RotorSport UK Ltd Service Bulletin

Title: MT-series Pre-rotator reinforcement stay		
SB No.: 066 Iss1	Related documents MC No: 242 CCAR No.: 034	Compliance Category:
Applicability		OPTIONAL <small>or</small> RECOMMENDED or MANDATORY
Aircraft type & model: MT-03, MTOsport	Aircraft serial Nos. affected: RSUK/MT03/any, RSUK/MTOS/any

The aluminium pre-rotator bracket on a number of MT-03 and MTOsport subject to hard usage has been found with a small crack. Fitment of a strengthened bracket under Service Bulletin SB-027 has not entirely remedied the problem. A reinforcement stay is now available and can easily be fitted to provide greater support to either the standard or the strengthened pre-rotator bracket. The stay is supplied with required fasteners as service kit RSD7227.

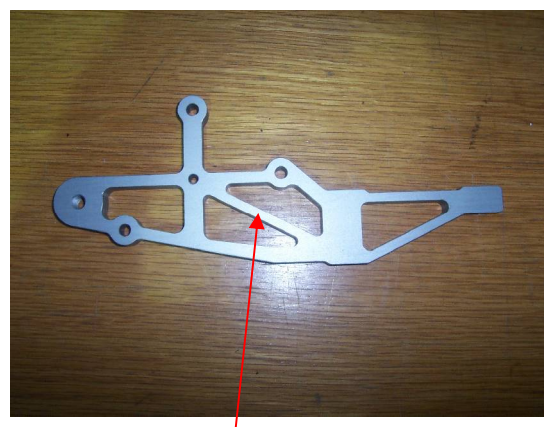
Previous Modifications that affect the SB
As a result of progressive design changes and Service Bulletin -027 there are three generations of pre-rotator bracket in service, all will accept this modification.

(1) Original under RSD5023

(2) Thicker webs under M.PR01.06.01.001

(3) Additional web under M.PR01.06.01.003

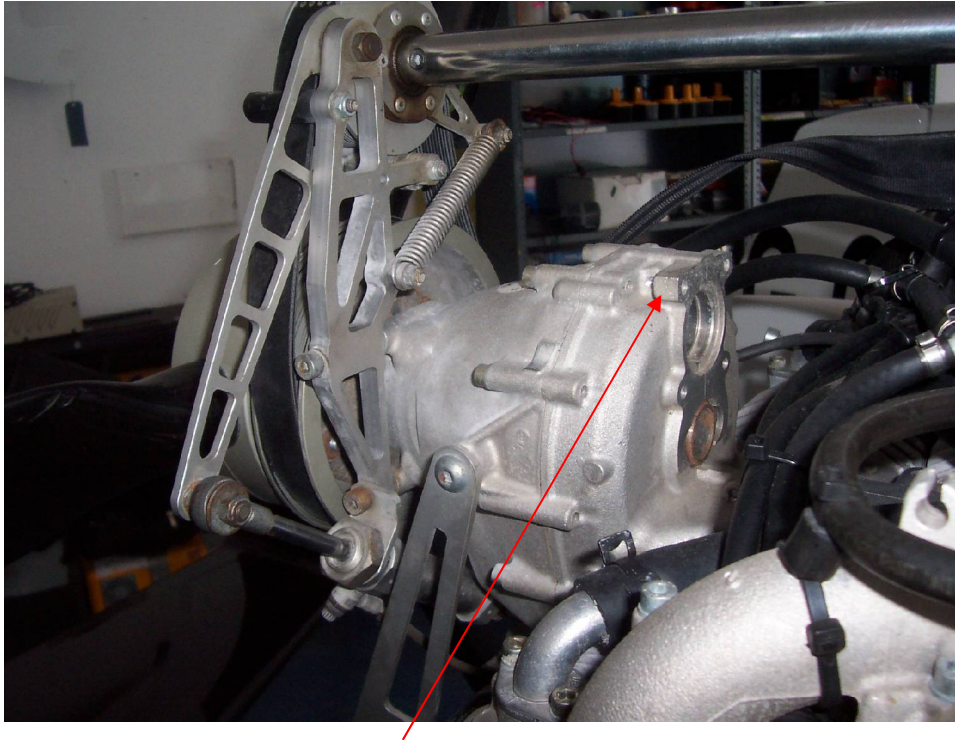
Working adjacent to the pre-rotator pulley hold the M6x60 capscrew with an allen key and release the nyloc nut. Remove the capscrew from the brake tube and dispose of both fastener parts.

Fit the M6x65 screw through the tube and re-assemble to the bracket. Fit the new pre-rotator stay using a new nyloc nut and tighten finger-tight only.

If the brake tube has a flat worn on to its surface rotate the tube so that this is away from the belt.

Finished installation

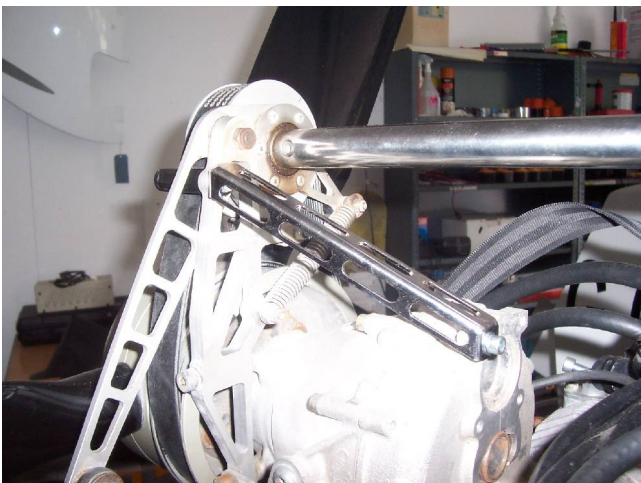
Move the stay into position and check the clearance between the inner face of the stay and the bracket of the gearbox. Select M6 plain washers to just fill the clearance then fit a further washer to the M6x16 capscrew and screw into place with Loctite243 on the threads.

Tighten the lower capscrew and upper nyloc nut. There should have been no disturbance of the pre-rotator system and no adjustment is required.
